UNITED STATES PATENT AND TRADEMARK OFFICE

| APPLICATION NO. | FILING DATE | FIRST NAMED INVENTOR | ATTORNEY DOCKET NO. | CONFIRMATION NO. |
|-----------------|-------------|----------------------|---------------------|------------------|
| 09/532,576 | 03/22/2000 | Peter W. Hamilton | 7995 | 8660 |

Office Action Summary

RESPONSE TO AMENDMENT

Fig. 11 *skt*

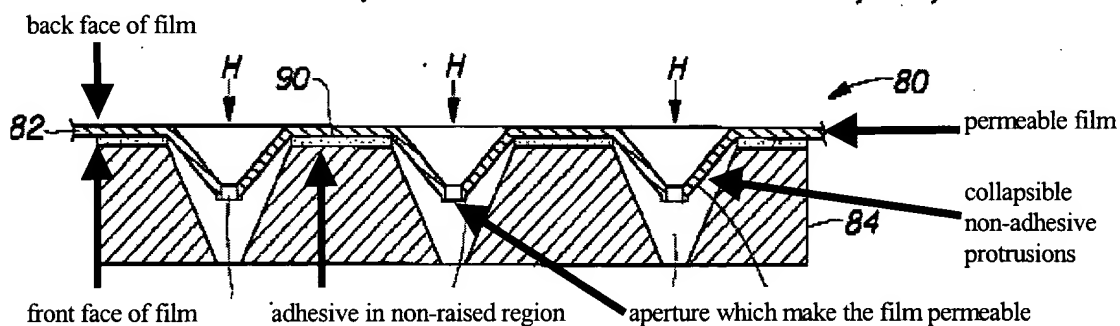
Regarding Applicant's claim 21, *Hamilton '607* discloses an adherent sheet material comprising "[a]dhesive" (*col. 4, line 29*) non-raised region protected from inadvertent adherence to a contact surface (*col. 17, lines 41-43*), the sheet material comprising an apertured film, which makes the film permeable/porous, having a front and back face (*col. 13, lines 13-20 and figure 11*). The front face has a plurality of collapsible, non-adhesive protrusions extending outwardly from said front face and adhesive, non-raised region disposed between the protrusions (*col. 17, lines 41-62; col. 13, lines 13-20 and figure 11*).

Hamilton '607 discloses that the protrusions have a base diameter of about 0.015 inches to about 0.03 inches, which using the formula for the area of a circle ($A=0.25 \cdot D^2 \cdot \Pi$), gives a surface area from about 0.0002 inches to about 0.0007 square inches and has a center-to-center distance from about 0.03 inches to about 0.06 inches (*col. 9, lines 5-19*). From the figures it can

be seen that the protrusions have a dome-shape. This reads on applicant's claimed protrusions having a base diameter from about 0.03 to 0.1 inches, a base surface area from about 0.0007 inches to about 0.008 square inches and a center-to-center distance from about 0.05 inches to about 0.15 inches. Since, the protrusions of Hamilton are within the claimed ranges for the base diameter, base surface area and center-to-center distance for the protrusions it would be expected that they would have the number density of protrusion, i.e. from about 10 to about 175 protrusions per square inch.
